## HISTORIC AND DESIGN REVIEW COMMISSION

**HDRC CASE NO:** 2021-213  
**ADDRESS:** 222 BEAUREGARD  
**LEGAL DESCRIPTION:** NCB 743 BLK 2 LOT 1 MASTERFILE & COMMON ELEMENT -MADISON CONDOMINIUMS  
**ZONING:** RM-4, H  
**CITY COUNCIL DIST.:** 1  
**DISTRICT:** King William Historic District  
**APPLICANT:** Lyndsay Thorn/Thorn Architects, PLLC  
**OWNER:** Sean Moore (Wife: Blythe Evans)/MADISON CONDOMINIUM OWNERS ASSOCIATION INC  
**TYPE OF WORK:** Window sash replacement  
**APPLICATION RECEIVED:** April 23, 2021  
**60-DAY REVIEW:** Not applicable due to City Council Emergency Orders  
**CASE MANAGER:** Huy Pham  
**REQUEST:**

The applicant is requesting a Certificate of Appropriateness for approval to replace non-original window windows with new aluminum-clad wood windows matching historic specifications (Pella Reserve Traditional Series)

**07** | LIVING ROOM WINDOW  
Facing Courtyard

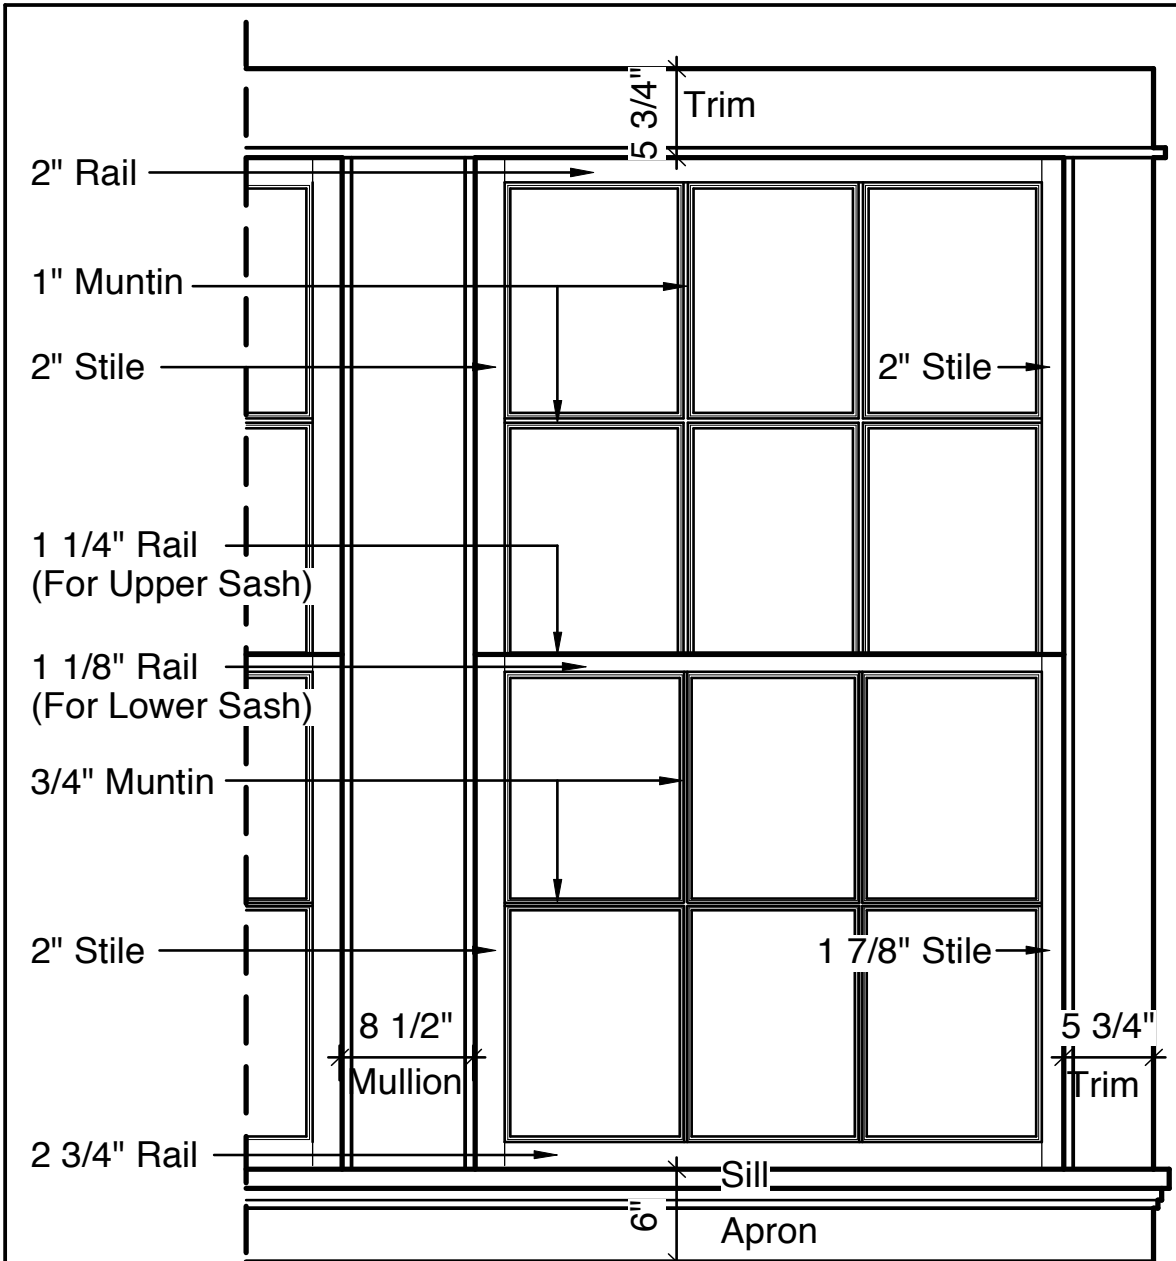
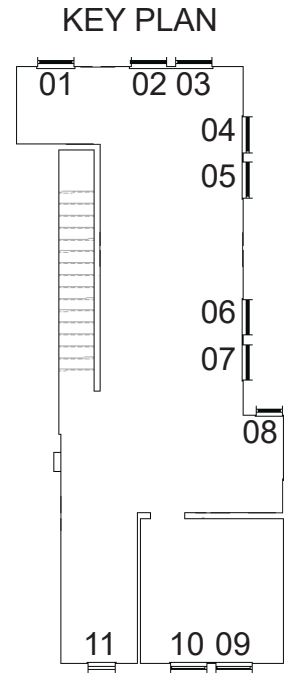
- b. EXISTING WINDOWS – The applicant has provided thorough documentation of each window regarding their varying trim, stile, rail, and sash sizes and concluded that Window 07 and Window 08 are likely feature the most original dimensions while the other windows have been subject to minor alterations through their lifetime based on milling details, historically common sizes, and visible wood grain detail. Staff conducted a site visit on April 19, 2021 and concur with the applicant's findings on original elements. Per the *Standard Specifications for Wood Window Replacement*, when individual elements such as sills, muntins, rails, sashes, or glazing has deteriorated, every effort should be made to repair or reconstruct that individual element prior to consideration of wholesale replacement, and where original windows are found to be missing or previously-replaced with a nonconforming window product by a previous owner, an alternative material to wood may be considered when the proposed replacement product is more consistent with the Historic Design Guidelines in terms of overall appearance. Regarding condition, staff finds that the windows are generally intact and still have function weight-pulleys, with the exclusion of front-facing Window 02 and 03 with failing or missing meeting rails. Staff finds that wholesale replacement is appropriate based on the documentation of non-original elements to provide a uniform appearance while maintaining documented historic window dimensions and details.

- REPLACEMENT WINDOWS – If replacement is approved, the applicant has proposed to use Pella Reserve Traditional Series aluminum-clad wood sash windows matching window 07 and 08 in all dimensions, milling details, and six-over-six configuration. Per the *Standard Specifications for Wood Window Replacement*, if full window replacement is approved, the new windows must feature primed and painted wood exterior finish. Clad, composition, or non-wood options are not allowed unless explicitly approved by the commission. Staff finds that a fully wood window should be used instead of aluminum-clad to maintain the existing conforming condition of wood windows, even if they may not be the original wood windows.

Staff recommends approval of window replacement based on finding b with the stipulation that a fully wood window is used instead of aluminum-clad to maintain the existing conforming condition of wood windows, even if they may not be the original wood windows. Staff finds the proposed product Pella Reserve Traditional Series otherwise adheres to the *Standard Specifications for Wood Window Replacement*.
